**Subject** ► Change on head complete, change ring, etc.

**For Models** ► 6702D/DW (Cordless Angle Socket Driver)

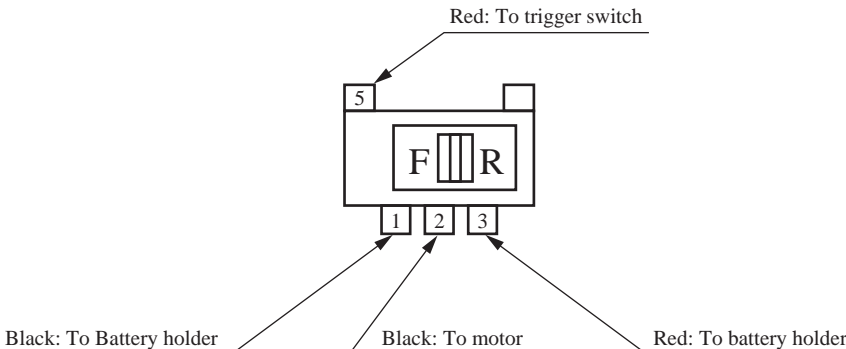
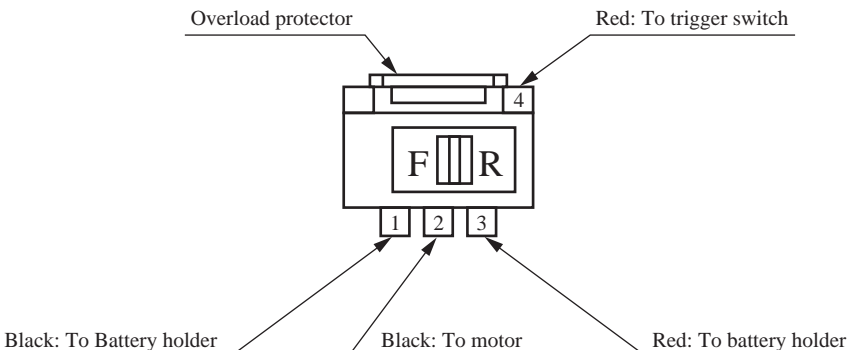
**Description** ► 1. The head complete and the change ring will be changed as follows.

<p>► <b>Current</b></p> <p>The torque can be adjusted in 5 stages (20 kg.cm - 80 kg.cm; 1.4ft.lbs - 5.8 ft.lbs).</p>	
<p>► <b>New</b></p> <p>The torque can be infinitely adjusted from 20 kg.cm - 80 kg.cm(1.4 ft.lbs - 5.8 ft.lbs).</p>

2. The reversing switch will be changed. The new type switch will have an overload protector.

3. The housing (R) will be changed as follows.

- 1) The rib will be changed in shape.
- 2) A boss will be added.
